BEFORE THE PALMERSTON NORTH CITY COUNCIL INDEPENDENT HEARING PANEL

IN THE MATTER OF Plan Change E: Roxburgh Residential Area

**REPLY EVIDENCE OF CHRISTOPHER MURRAY MCDONALD ON BEHALF OF
PALMERSTON NORTH CITY COUNCIL**

16 May 2025

Figure 1: Early version of Structure Plan from *Urban Design Report* dated 13 July 2021.

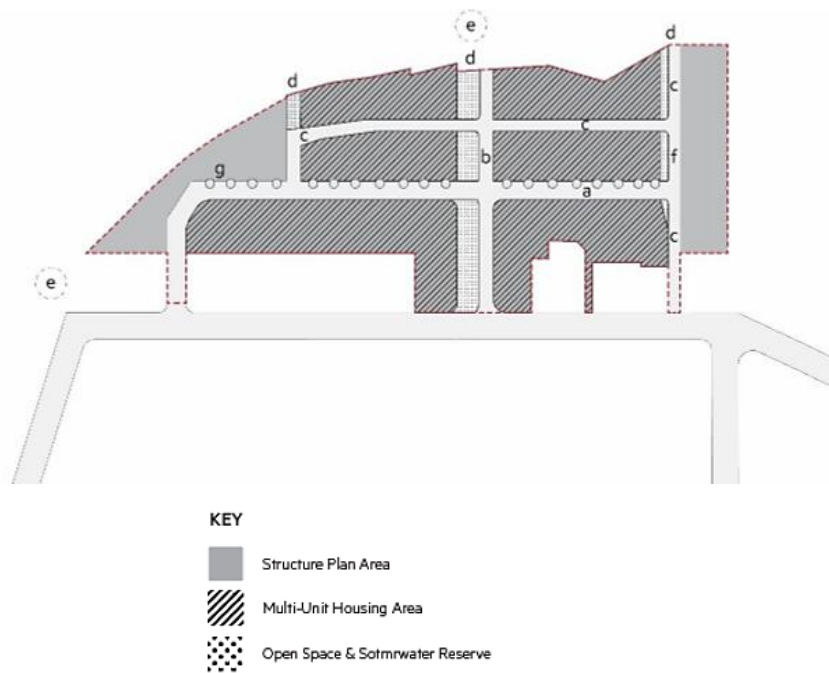
- 13 An earlier version of the Structure Plan (circa. 2021) responded to these conditions by introducing an 8m wide lane to the eastern side of the plan change area (see Fig.1). This lane has a similar trajectory to that of Local Street B as notified as part of PCE. However, the earlier plan anticipated a single row of lots between Roxburgh Crescent and the lane. This meant that most lots on the eastern side of Roxburgh Crescent had both a street frontage and a rear boundary with the lane, which provided vehicle access.

18 If a lane was to be considered for this area, I prefer the option set out in the earlier 2021 version of the Structure Plan. This structure plan option demonstrates that a well-designed lane could replace the northern arm of Local Street B, so long as:

- (a) Connectivity is maintained by joining Roxburgh Crescent with Local Street B.
- (b) Appropriate landscape and edge conditions ensure the lane appears to be an extension of the public domain. Provided the lane's trajectory is relatively simple, direct sightlines to adjoining streets would assist legibility and invite casual use.

19 At the same time, owing to reduced width, a lane as set out in the earlier 2021 Structure Plan would increase land-use efficiency in the tapered portion of the RRA.

- 22 I support this recommendation. As the Structure Plan evolved, the reserve's location shifted from the north side of Road D to the south side. Figure 1 depicts the earlier arrangement. In my recollection, sun access was a decisive factor in the change. Adjoining housing is more likely to shade the reserve if the open space is located on the north side of Road D. However, sun access is a less critical issue for PCE than it was for earlier versions of the Structure Plan because these anticipated three-storey terrace houses along both sides of Road D. Given the proposed 9m height limit, I consider there is merit in allowing the reserve's exact location to be determined as part of a future subdivision layout.

20 Having regard to the benefits described in paragraph 17 associated with Local Street B, I remain of the view that this is the best option for the plan change area. However, so long as any lane was delivered as part of the development (not optional) and in the manner I note above, then, a lane could provide an alternative connection to the Northern Block.

- 42.a.1 The central open space reserve could be located either north or south of Local Road D; and
- 42.a.2 Although for the reasons I have explained I consider it preferable to retain Local Street B as proposed, the northern arm of this street could be replaced by a well-designed lane if considered necessary.
